**COMMONWEALTH OF KENTUCKY  
TRANSPORTATION CABINET**  
Frankfort, Kentucky 40622  
[www.transportation.ky.gov/](http://www.transportation.ky.gov/)

CALL NO. 100  
CONTRACT ID NO. 161270  
ADDENDUM # 3

Subject: Rockcastle County, NHPP IM 0753 (092)  
Letting December 21, 2016

- (1) Revised - Bid Items - Pages 168-172 of 172
- (2) Added - Special Note - Pages 1-6 of 6

### SPECIAL NOTE FOR BARCODE LABEL ON PERMANENT SIGNS

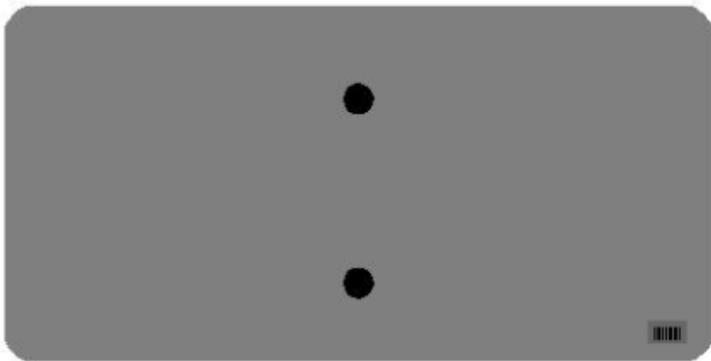
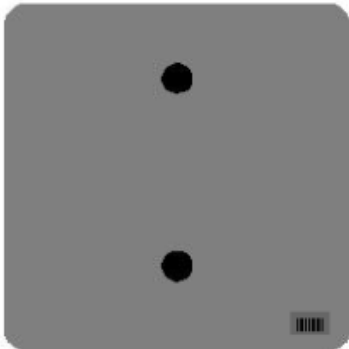
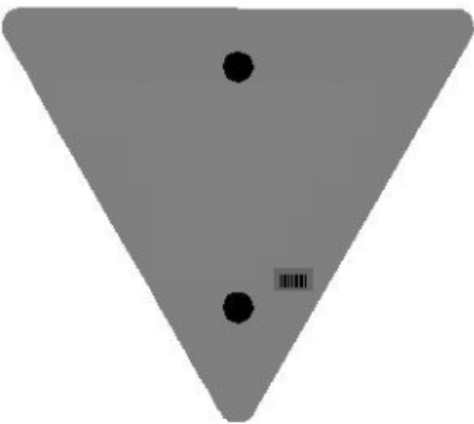
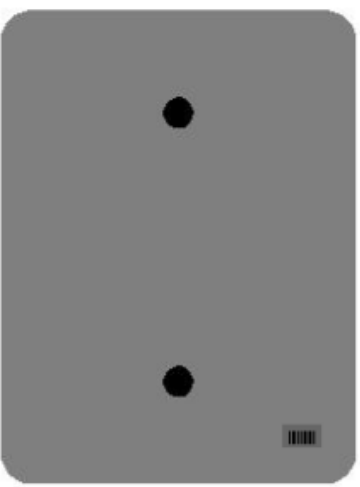
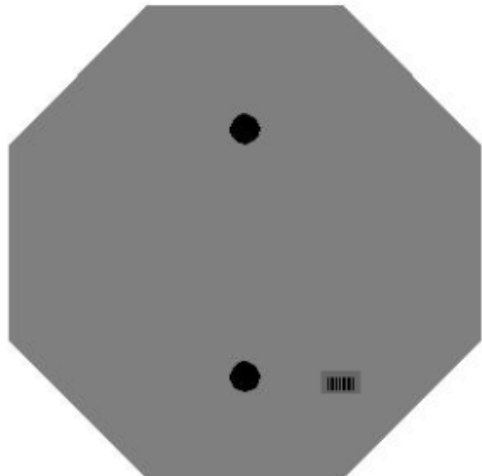
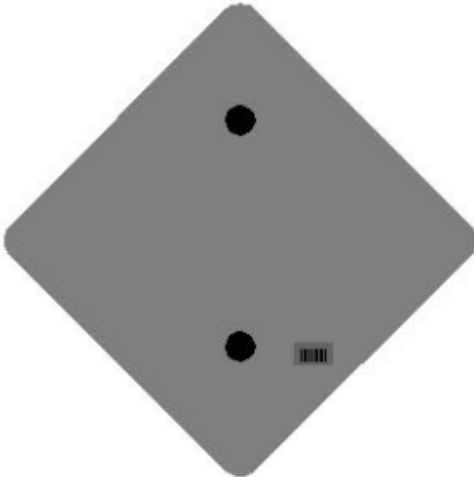
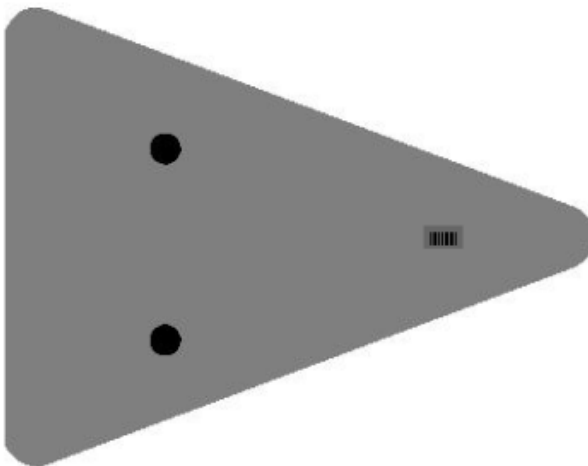
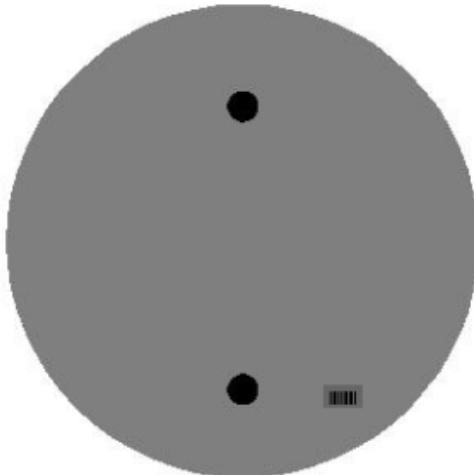
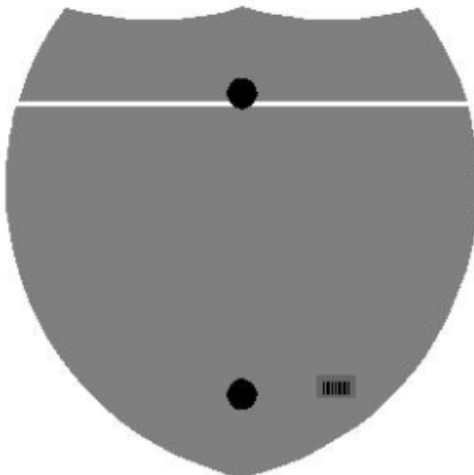
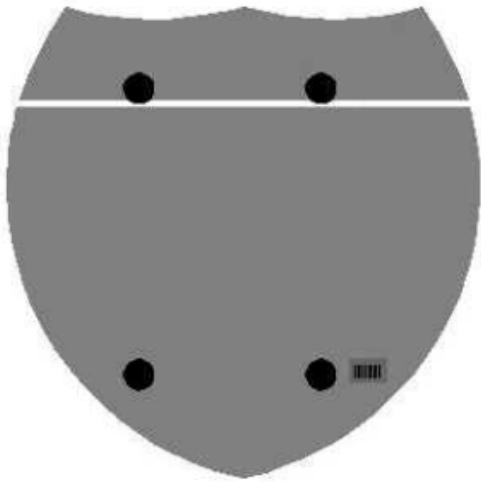
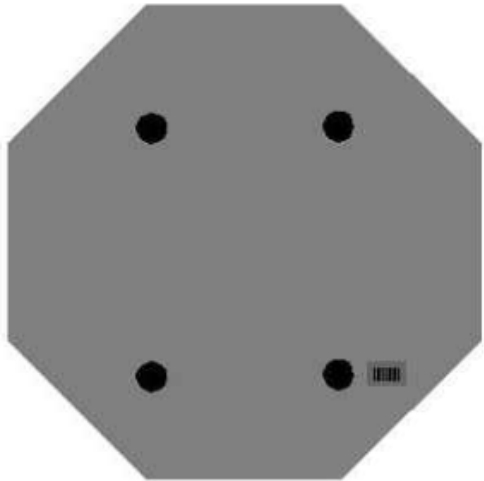
**3.0 CONSTRUCTION.** Apply foil barcode label in the lower right quadrant of the sign back. Signs where the bottom edge is not parallel to the ground, the lowest corner of the sign shall serve as the location to place the barcode label. The barcode label shall be placed no less than one-inch and no more than three inches from any edge of the sign. The barcode must be placed so that the sign post does not cover the barcode label.
